PERMANENT FILE NO. 25915

KRANTZ PROPERTY

NE 1/4 S 31 T7N R8E

TOWN OF MIDDLETON, DANE COUNTY

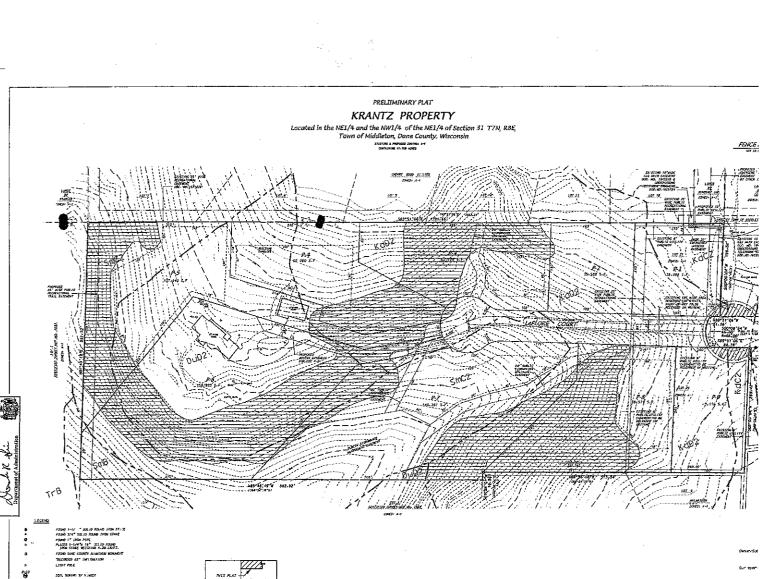
We have examined and find that, with the exceptions noted below, this preliminary plat appears to conform with the applicable layout requirements of ss. 236.16 and 236.20, Wis. Stats.

Note for the final plat: The location description under the plat name and in the Surveyor's certificate must reference the existing subdivision lots included in this plat; the date and method of the street vacation must be noted.
